ADDENDUM NUMBER 3
for
ADVANCED TREATMENT PROJECT
FORT THOMAS TREATMENT PLANT
NORTHERN KENTUCKY WATER DISTRICT

FROM: CH2M HILL
TO: Plan Holders of Record

CONCRETE STEP REPLACEMENT PLAN

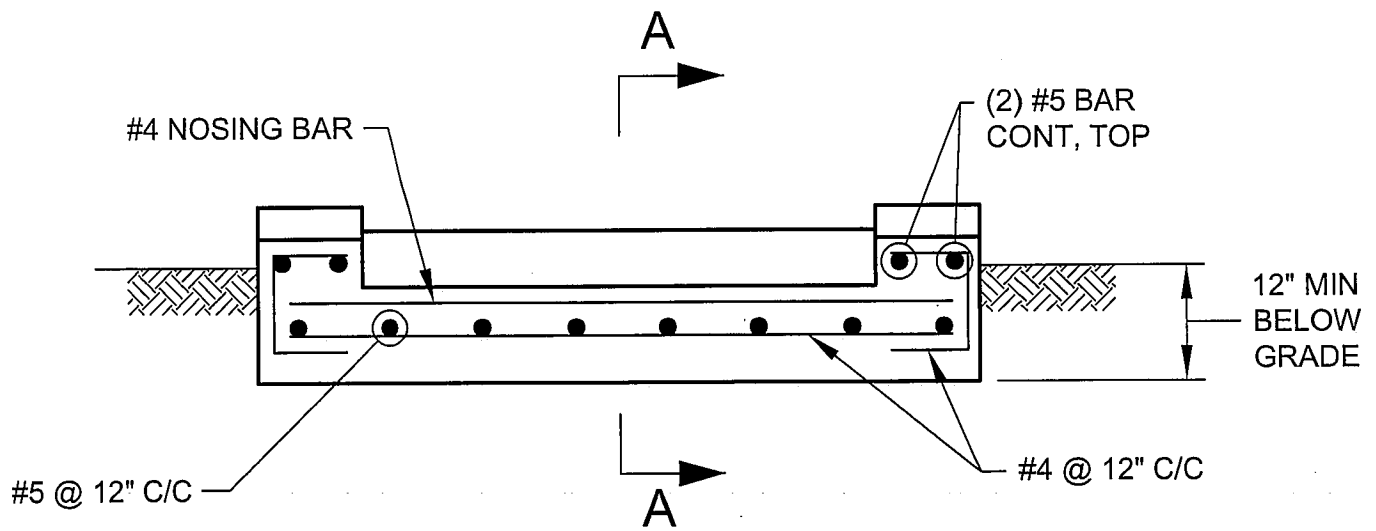
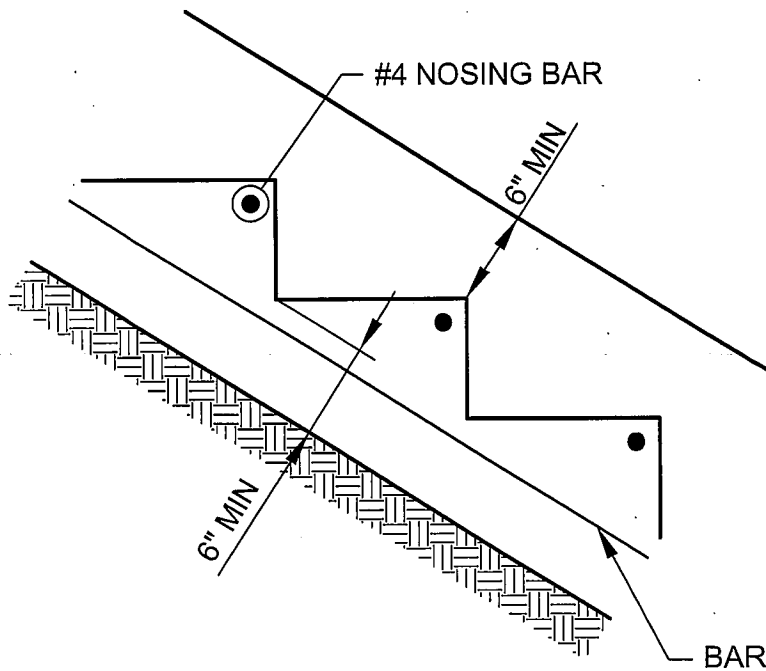
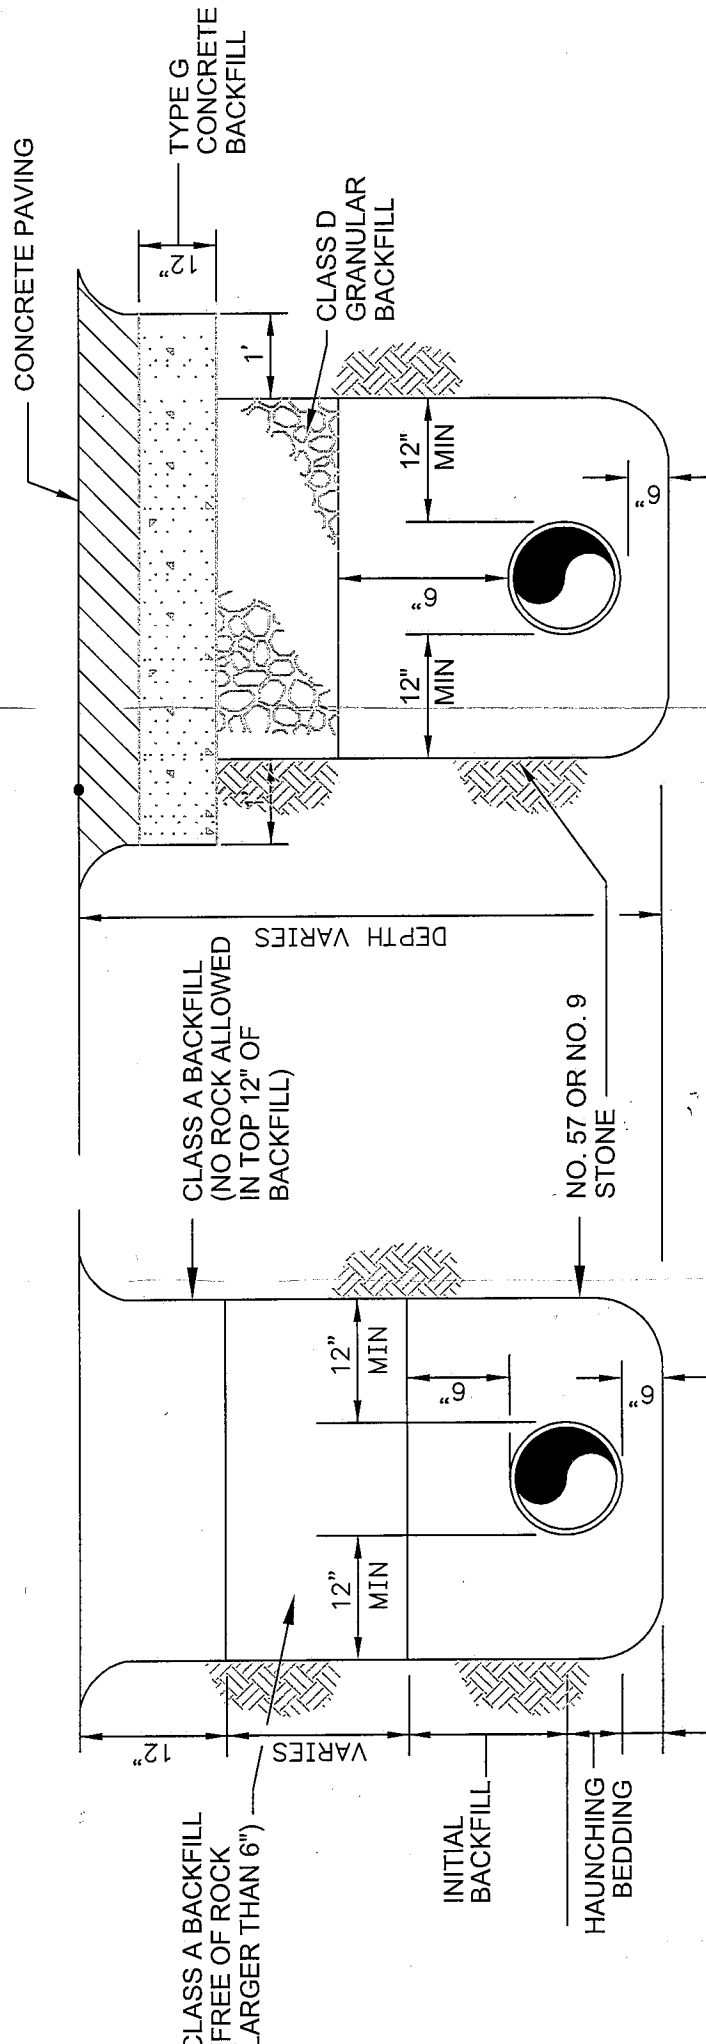
Revise the note for the concrete steps at west side of the existing filter building from "Replace concrete steps w/ step size of 7" riser & 11" tread" to "Replace concrete steps per attached details"
